At your request a visit was made to the referenced address on May 4th, 2026 to inspect the structure, with particular attention to items recently noted in a prior home inspection report. Public property records indicate this house was built in 1977. With homes of this age, one can expect there to be some framing conditions that do not meet today's Code requirements. With that in mind, the repairs recommended in this report are intended to prevent further deterioration and address damaged areas or areas of insufficient support that may influence the safety and performance of the structure under normal use. The following items were noted at the time of the inspection with any photos relevant to that item immediately following:

Garage Ceiling Repair Plan

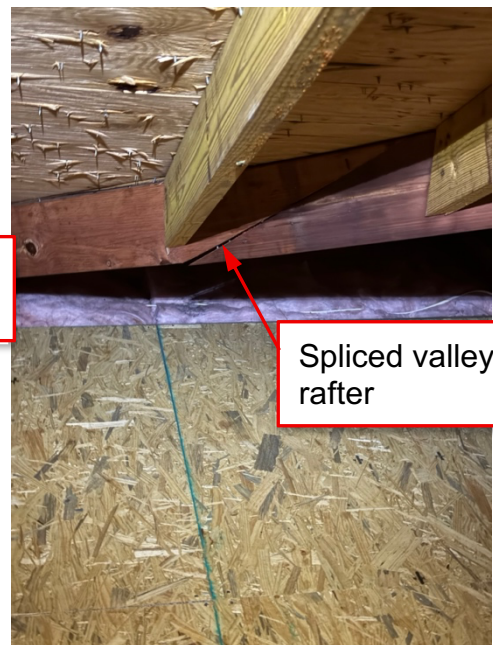
2. At the rear center attic area forward of the chimney, the overbuild roof framing includes a hip rafter with a birdsmouth splice that lacks adequate bracing. This condition should be corrected by installing a roof brace at this splice. Additionally, the peaks of the hip rafters where they meet the ridge board should be braced. These braces should bear over the beam spanning across the living room to ensure proper load transfer. See the photo on the following page.

Add double 2x4
braces

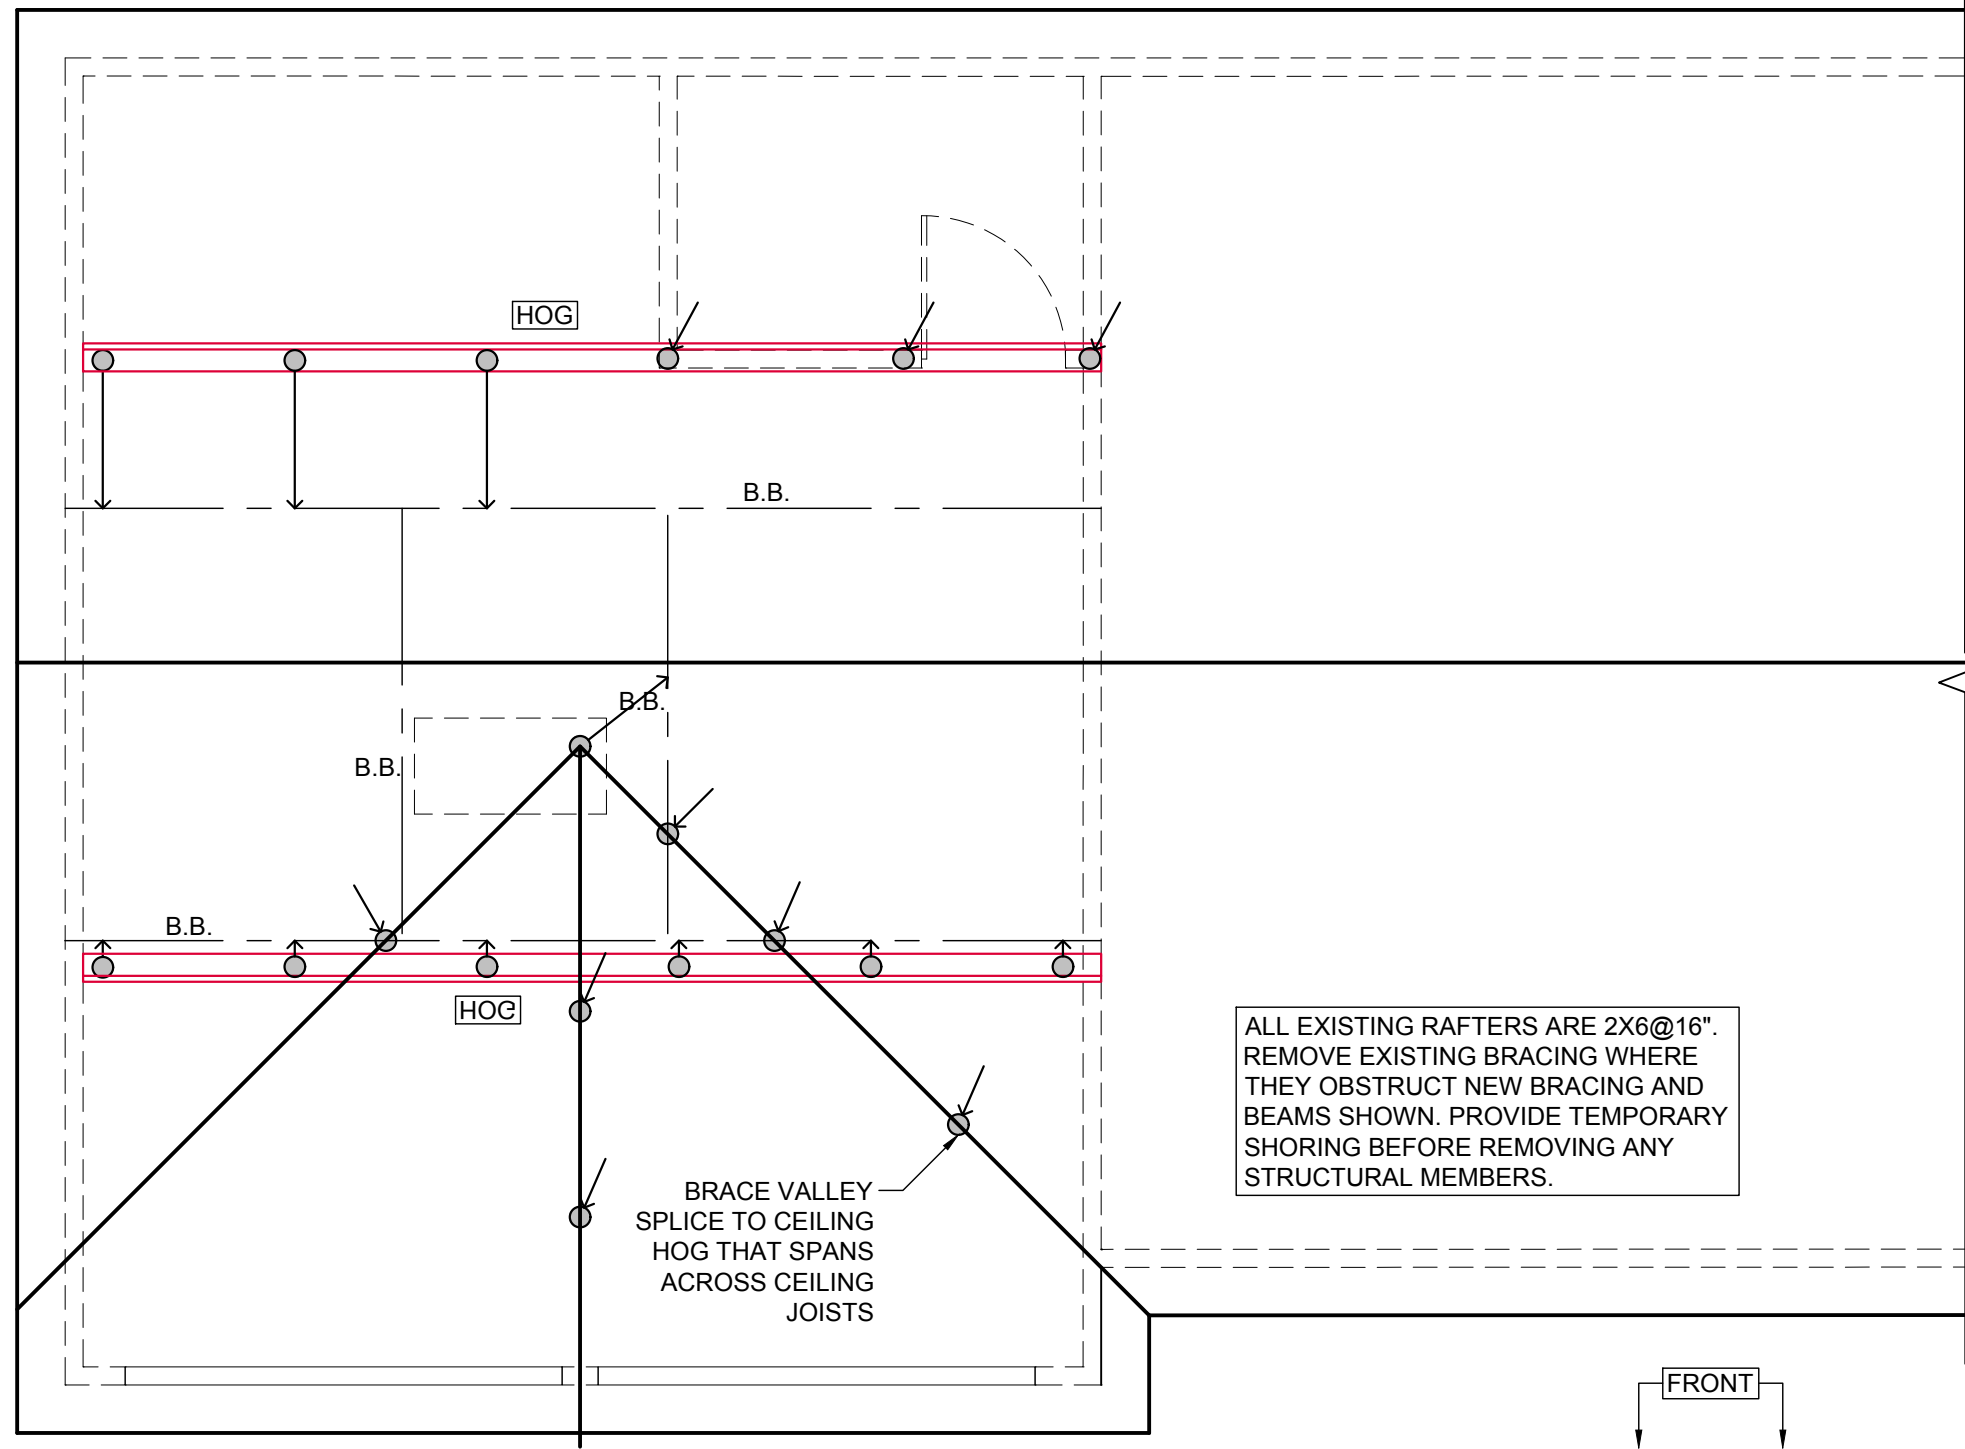
3. The ceiling over the garage exhibits a significant sag, which is attributable to overspanned ceiling joists running laterally across the garage. The original construction attempted to create a site-built truss system; however, the geometry of the roof prevents this system from functioning as intended. As a result, the roof and ceiling framing over the garage has sagged, is deficient, and requires reinforcement. Installation of properly designed beams within the garage ceiling is necessary to adequately support the roof structure, consistent with the referenced repair approach. See the attached repair plan for further information.

Inadequate Site-
built trusses

Spliced valley
rafter
